PRODUCT BULLETIN

ISSUE/DATE:	March 04, 2015	BULLETIN NUMBER:	AQ030415
SUBJECT:	Lamp Socket Lead	PRODUCT LINE:	Aquafine
TOPIC:	SINGLE ENDED LAMP SOCKET LEAD REVISION CHANGE

REVISION CHANGES

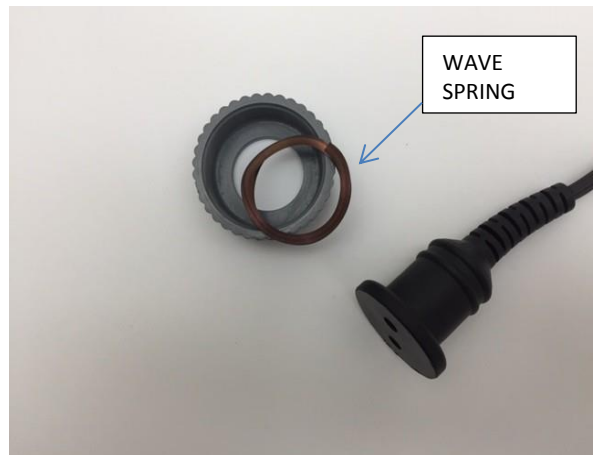
Aquafine Corporation has qualified a new wave spring to replace the old Delrin washer inside the single ended lamp socket assembly. This change is a part of continuous improvement and product enhancement with no change to fit, form and function. The Delrin washer may deteriorate over the time but the new wave washer will not deteriorate as it is made of stainless steel material.

Please note that this wave spring P/N 47597 is a direct replacement of existing Delrin washer P/N 47518.

DELRIN WASHER

WAS: P/N 47518 Series

WAVE SPRING

NEW: P/N 47597
